Discussion: Support in shallow mines using horizontally reinforced systems*

Contribution by M. D. G. SALAMON†

* Paper by J. A. Hahn, G. E. Blight, and L. Dison published in *J. S. Afr. Inst. Min. Metall.*, vol. 82, Oct. 1982, pp. 277-290.

Fig. 1—Relationship between working height and depth for 60 per cent extraction

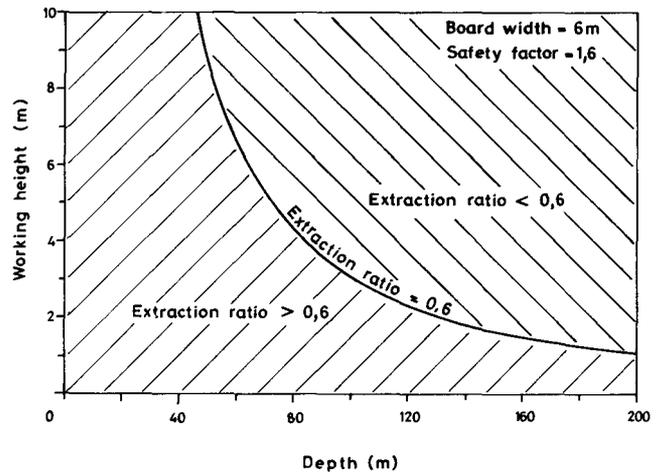
Assume that a thick seam of coal exists at a depth of 100 m. According to Fig. 1, the use of artificial pillars at this depth would break even at a working height of about 3 m. To give the artificial pillars a chance of

economic success, a working height of 4 m is postulated. If the board width and safety factor are left unaltered, the procedure of pillar design for this geometry yields a width of coal pillar of 11,9 m, which is equivalent to an extraction of 55,7 per cent. It is estimated on the basis of some detailed theoretical work^{1,3} and field observations^{1,3} that the surface subsidence over these workings would be in the region of 7 to 8 mm.

We do not agree with Dr Salamon's analysis of the compression of a 4 m high artificial pillar under a stress of 10 MPa. If the pillar has a modulus of compression of 600 MPa, the strain in the pillar will be 1/60 and the pillar convergence $4000/60=67$ mm. Hence, we presume from Dr Salamon's figures that the surface subsidence would be about 10 mm, and not 100 mm as he states.

Fig. 2—Strength enhancement due to lateral reinforcement

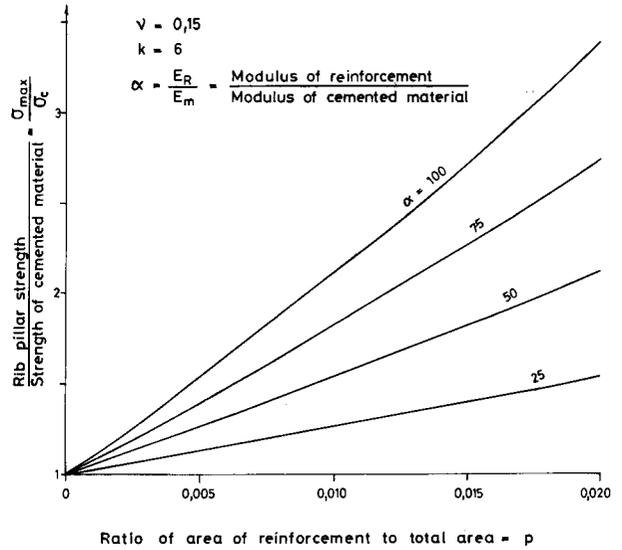
The results corresponding to long rib pillars can be obtained from those in (2) to (4) by the multiplication of factors $(1-\nu)$ and ν wherever they occur by $(1+\nu)$. To derive these latter results, plane-strain conditions were postulated. In Fig. 2 the strength of a rib pillar is plotted as a function of the reinforcement area for various values of the ratio of moduli. These results do not appear to differ greatly from those depicted in Fig. 8 of the paper (p. 281). However, it is important to note that the strength is strongly dependent on the value of the Poisson's ratio and that it *increases* as the Poisson's ratio is *increased* (Fig. 3).

Fig. 4—Tensile stress in the reinforcement

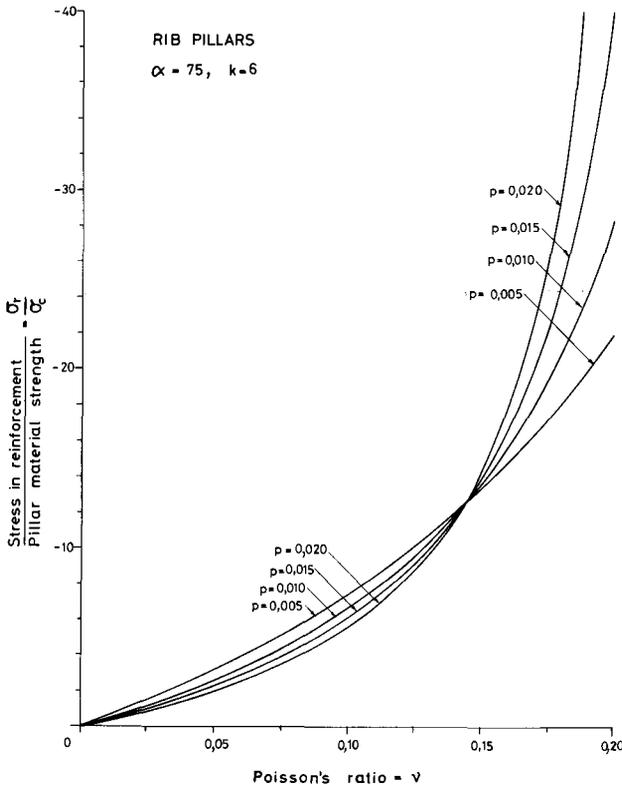
There are two criteria that must be satisfied if the integrity of the artificial pillars is to be assured: it is necessary for the pillar strength in (2) and the yield strength of the reinforcement material to exceed the pillar load and the tensile stress in (3), respectively. The latter criterion is not mentioned in the paper in respect of

pillars constructed from cemented material. This is a serious omission. It is clear from Fig. 4 that the tensile stress in the reinforcement may well become a critical condition for pillar soundness.

Another point missed by Dr Salamon is that the reinforced material is deemed by equation (10a) to have failed when the strain in the reinforcing is $200 \cdot 10^{-6}$. As the yield strain of mild steel is $1000 \cdot 10^{-6}$ (again no substantiation is deemed necessary) and its failure strain 20 per cent, there is absolutely no chance that the tensile stress in the reinforcing will become a critical condition.

Fig. 1—Stress distribution around a 200 m-wide total extraction panel situated at a depth of 100 m. The panel is supported by artificial pillars that are constructed from a material with a modulus of compression of 1 GPa. Because the panel is symmetrical, only the right-hand side is shown.

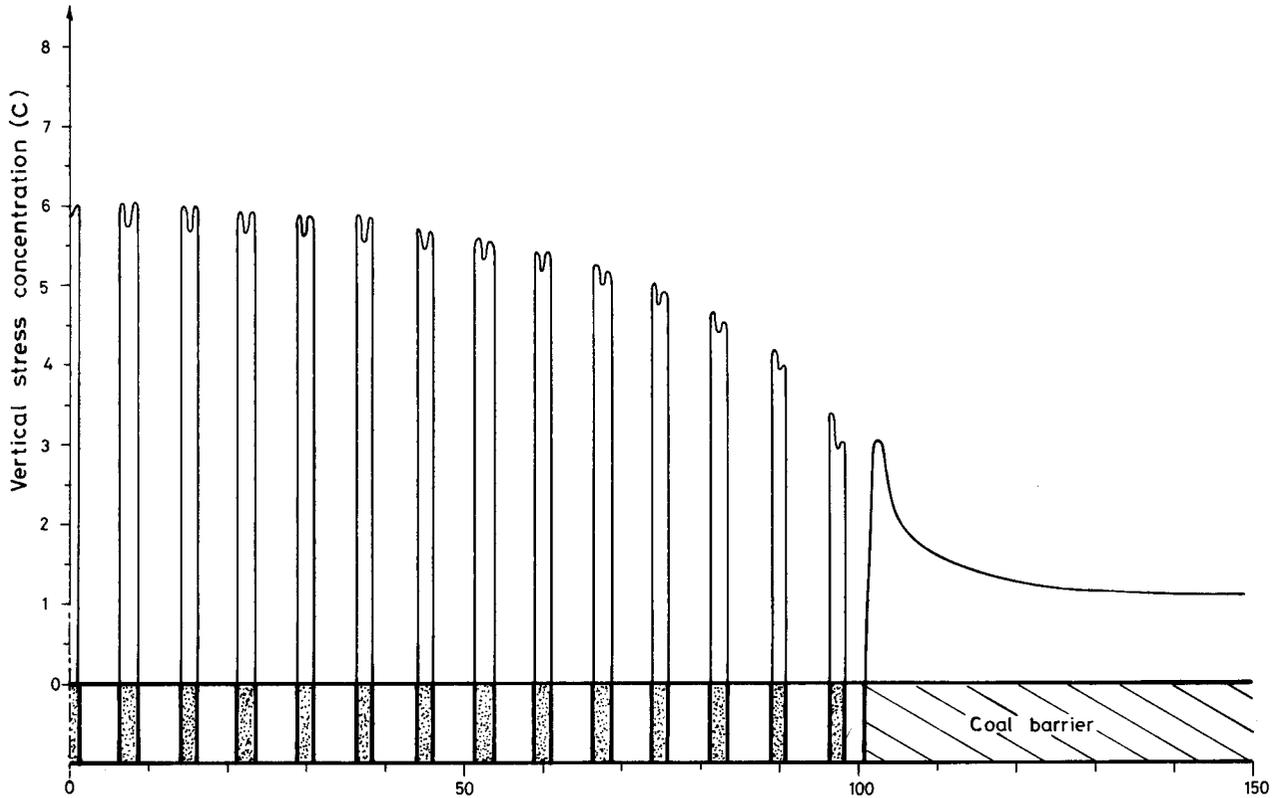
Fig. 1 shows the distribution of vertical stresses acting on the abutments and internal support pillars. For convenience, the stress values have been normalized with respect to the value of the vertical component of primitive stress. In the example, continuous artificial rib pillars 1,2 m wide and 1,8 m high, which are separated by 6,3 m wide bords, have been modelled. The compressive modulus of the pillar material in Fig. 1 is 1 GPa.

It is interesting to follow through the example illustrated by their Figs. 1 and 2 by looking at the actual stresses represented by the stress concentration factor C . Taking the unit weight of the overburden strata as 25 kN/m^3 , the overburden stress is $2,5 \text{ MPa}$ and the stress on the abutment $7,5 \text{ MPa}$. According to reference 5 of Dr Salamon's discussion, the abutment, if treated as a wide pillar, would fail at a stress considerably in excess of this. Hence, the factor of safety against failure of the abutment appears to be well above 2. The design strength for the artificial pillars would be $1,6 \cdot 2,5 \cdot 6,25 = 25 \text{ MPa}$. Reference to our Fig. 13 shows that, even if ash were used as backfill, a reloading modulus of 2 GPa would be possible and, with sand backfill, easily attainable. This would reduce the abutment stress to $2,3 \cdot 2 \cdot 5 = 5,75 \text{ MPa}$, which gives a factor of safety of more than 3 against failure according to reference 5. This encourages us to think that, with some further design and tailoring of the properties of the rib pillars, the hypothetical layout illustrated in Fig. 1 of the discussion would be feasible.

Fig. 2—Effect of the reloading modulus of the pillar material on the stress concentration at the internal support pillars and the panel abutments.

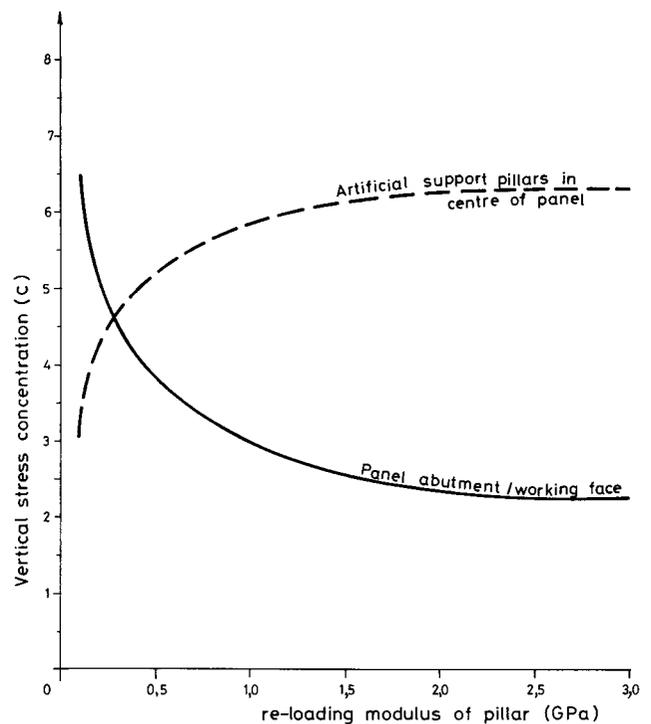
In Fig. 2 the maximum stress concentration on the artificial support pillars and the panel abutments is plotted as a function of the modulus of compression of the pillar material. The upper value of 3 GPa corresponds to the *in situ* modulus of elasticity of coal. Two important observations can be made from the trends shown in Fig. 2. First, the artificial support pillars in the centre of the panel carry a significant proportion of the overburden load only if the modulus of compression of the pillar material exceeds a value of 1 GPa. In terms of the tributary-area concept, the vertical stress concentration, C , in the artificial support ribs of width, b , which are separated by bords of width s , is

With the appropriate values for $s=6,3$ m and $b=1,2$ m, a stress concentration of 6,25 results. Second, in the case of support pillars having a modulus of compression of less than 1 GPa, most of the weight of the overburden in the mined-out area has to be carried by the panel abutments and the working face. The rapid increase in

the stress concentration at the panel abutments and working face for low values of pillar modulus of compression is evident from Fig. 2. High stress concentrations at the working faces can give rise to serious strata-control problems, and often require special support measures. In this connection, mention must be made of the difficult ground conditions encountered in total extraction panels when mining occurs under a thick sandstone roof or massive dolerite sills. An important feature of mining systems employing relatively soft support ribs is that the condition of high stress concentrations at the working face is maintained throughout most of the life of the panel, since it is the function of these ribs to prevent failure of the roof strata in the mined-out area.

Fig. 3—Effects of unsupported gaps between tops of support pillars and immediate roof contact or strata separation on the effective reloading modulus of the pillar material.

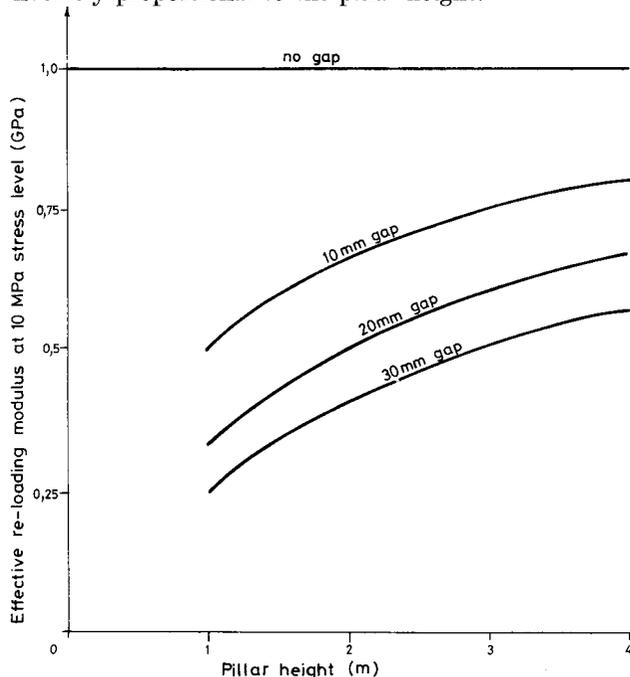
Fig. 3 gives an estimate of the effects of unsupported gaps on the reloading modulus of the artificial support pillars. The trends shown in the diagram are for a pillar material that has a reloading modulus of 1 GPa, and are valid for stress levels of 10 MPa. The effective reloading modulus of the pillar will be lower than shown in the diagram for stress levels below 10 MPa, but higher for pillar stress levels above 10 MPa. The influence of even very small gaps on the effective reloading modulus of pillars is very marked, and highlights the sensitivity of the artificial pillar system to operator abuse. If normal mining conditions and the operational environment are taken into account, it is difficult to visualize that values of pillar reloading modulus in excess of 0,5 GPa can be achieved consistently and reliably. It follows therefore that, under most conditions, the artificial pillars will carry only a relatively small portion of the weight of the overburden, while the panel abutments and working faces will be highly stressed. The need for prestressed support pillars has been recognized by the authors, but its importance on the working conditions in total extraction panels has not been fully appreciated.

providing artificial supports that are installed hard against the roof and are therefore as stiff as they are designed to be. We fully appreciate this difficulty and are giving it a lot of attention in our current research. We appreciate their treatment of the effect of pillar height on abutment stresses, and are relieved to find the effect so small. In our numerical example above, it appears possible to go to a pillar height of 5 m without causing the abutment stress to rise above $6,5 \text{ MPa}$ if the pillar reloading modulus is 2 GPa . This, once again, indicates that a feasible situation should be possible with careful design of artificial pillars. We would point out, in passing, that the stiffness of a horizontally reinforced pillar depends only on the height and compression modulus of the pillar, and not on its cross-sectional area.

Fig. 4—Effect of pillar height, h , on the stress concentration at the internal support pillars and the panel abutment. The depth of mining is 100 m, the panel width 200 m, and the reloading modulus of the material 1 GPa.

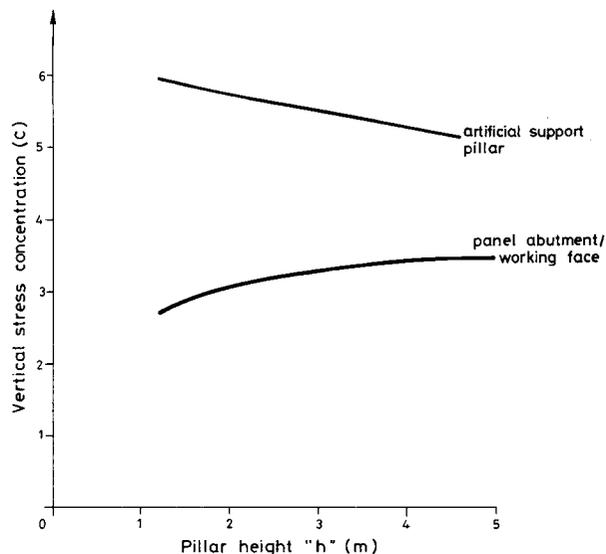
The influence of the latter on the stress concentration around a total extraction panel is examined in Fig. 4. The reduced efficiency of the artificial support pillars at higher seam thicknesses is evident. As was pointed out above, the stiffness of the support system, and consequently its effectiveness, can be improved by an increase in the pillar area. As attractive as this approach is from the point of view of strata control it results in unfavourable economics since the cost of the support system and the time required to install it increase more or less proportionally with pillar size.

Fig. 5—Vertical stress concentration around an existing bord-and-pillar panel in which pillars are extracted according to the concept of artificial support pillars. The depth of mining is 100 m, the seam thickness 1,8 m, and the modulus of compression of the pillar material 1 GPa.

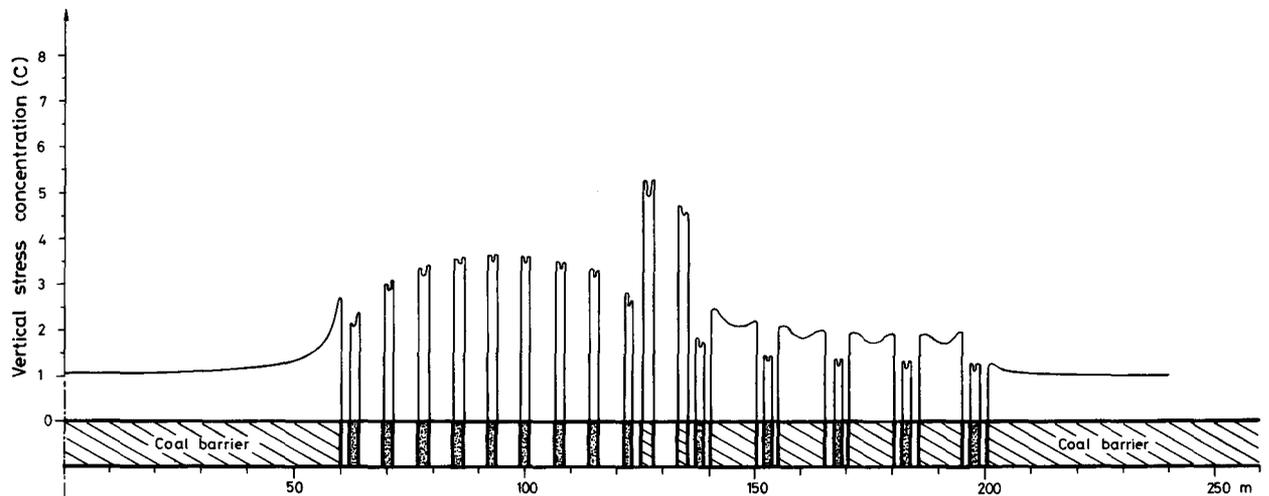
More serious than the economic aspects of the use of artificial support pillars in existing bord-and-pillar workings are some of the strata-control aspects. As an illustration of these, the extraction of coal pillars from existing workings situated at a depth of 100 m was examined. Fig. 5 shows the stress concentrations on the solid abutments, the intact coal pillars, the pillars under extraction, and the artificial support pillars. Despite the relatively small mining span of 60 m, the vertical stress concentration on the pillars that are being extracted is extremely high. Considering that the original pillars are designed with a safety factor that ranges typically from 1,6 to 2,5, it is immediately apparent that the pillars in the extraction line and its vicinity cannot withstand the very high stress concentrations without severe fracturing. The possibility of sudden failure of coal ribs in the extraction line cannot be denied. The implications of this become apparent if it is considered that most mining operations, including the installation of artificial support pillars, take place in this area. In conventional pillar-extraction operations, this danger is overcome largely by encouraging the roof strata to cave as soon after pillar removal as possible. To achieve this, a minimum amount of support is left in the mined-out area, and one of the golden rules of successful pillar

The situation represented by Figs. 5 and 6 certainly appears alarming. However, let us follow it through in terms of the dimensions used elsewhere in the discussion. The width of the unsplit coal ribs is not given, but let us assume that it is $6,3 \text{ m}$ with $6,3 \text{ m}$ bords. These sizes would fit in with the vertical stress concentration C of 2 shown in Fig. 5 for the unsplit coal ribs, and are the same as those used in Fig. 1. It would not be possible to split a pillar of this width and leave remnants of a sensible size in place. Therefore, we would suggest the building of two artificial ribs in each bord, each artificial rib being hard against the adjacent coal rib. For a vertical stress concentration of 4,5, these ribs could each be $1,5 \text{ m}$ wide, leaving a $3,3 \text{ m}$ bord between them. The coal rib could then be removed completely, leaving no remnants and resulting in a new bord between the artificial ribs of $6,3 \text{ m}$. Hence, again, we consider that a feasible system is possible by careful design.

Fig. 6—Effect of the modulus of compression on the stress conditions in pillar-extraction panels employing artificial support pillars. The depth of mining is 100 m, the extracted span 60 m, and the mining height 1,8 m.

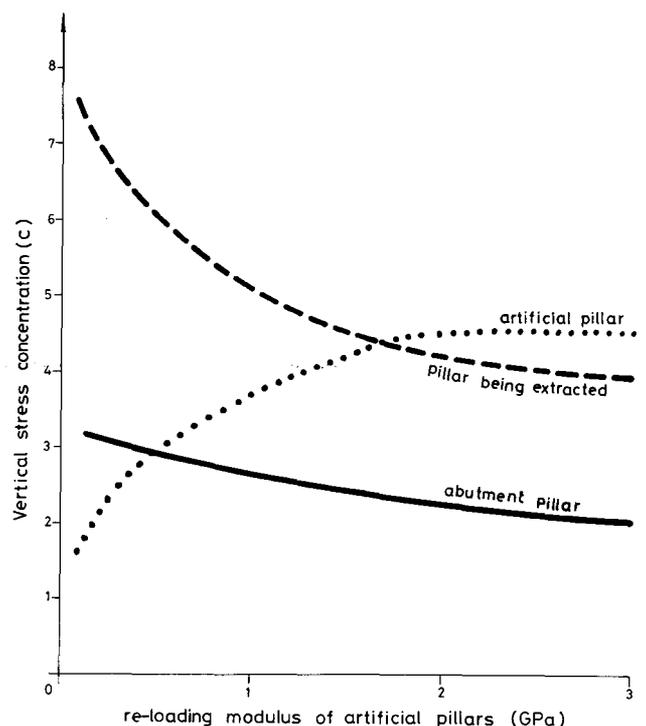
As in the previous case, the modulus of compression of the artificial support pillars is a critical design parameter. Fig. 6 shows how the stress conditions in the extraction panel depend on the modulus of compression of the artificial pillar material. Unlike the previous case,

a significant deterioration of the situation is observed at moduli of compression of as high as 2 GPa.
